Interpretation of Research on Fuel Fragmentation, Relocation, and Dispersal at High Burnup

Date Published: [Month] 2021

Prototypicality and Representativeness of Empirical Database	21
Discussion of Consequences and Consequence Modeling	22
Limitations of the Empirical Database	23
Summary and Conclusions	24
Acknowledgments.....	25
References	26
Appendix A: A Model for Predicting Dispersal	A-1
Appendix B: Summary of Peer Review Comments and Resolution	B-1

Figure 9 Illustration of fuel relocation and packing in the ballooned region

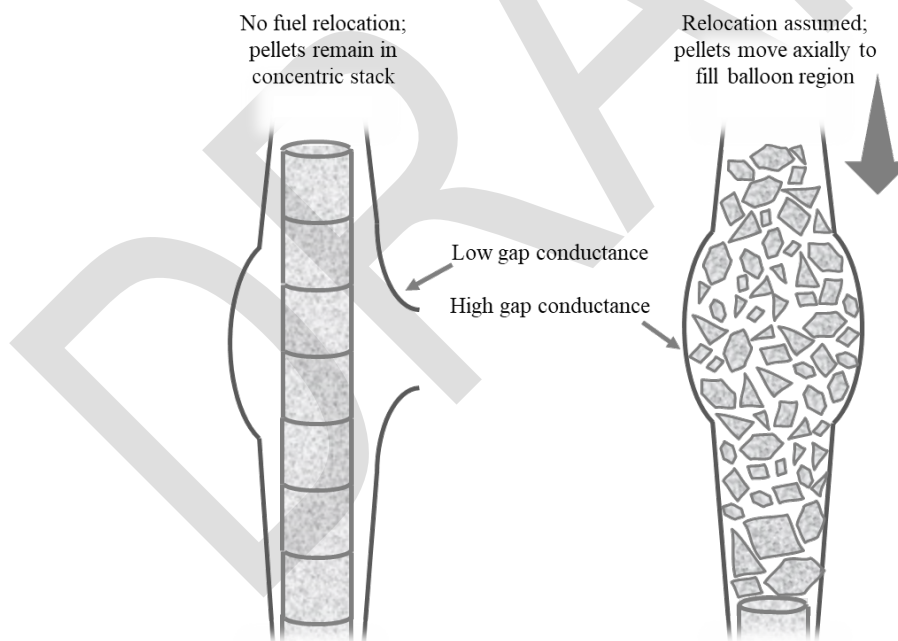
- Reviewers suggested removing references to low and high gap conductivity for cases without and with fuel relocation in Figure 9. This comment was not accepted.

Figure 12 Packing fraction of 3V5-Q13 (Magnusson, et al., 2020)

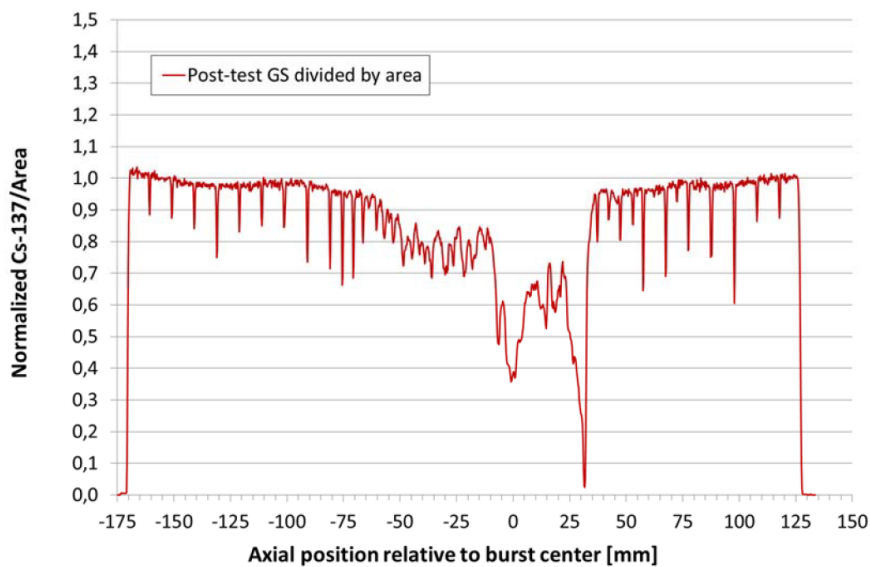
- Reviewers asked for clarification of how the axial distribution of packing fraction in Figure 12 relates to single values of the packing fraction cited for the various tests. This comment was accepted, and discussion was added about the particular test shown in Figure 12.
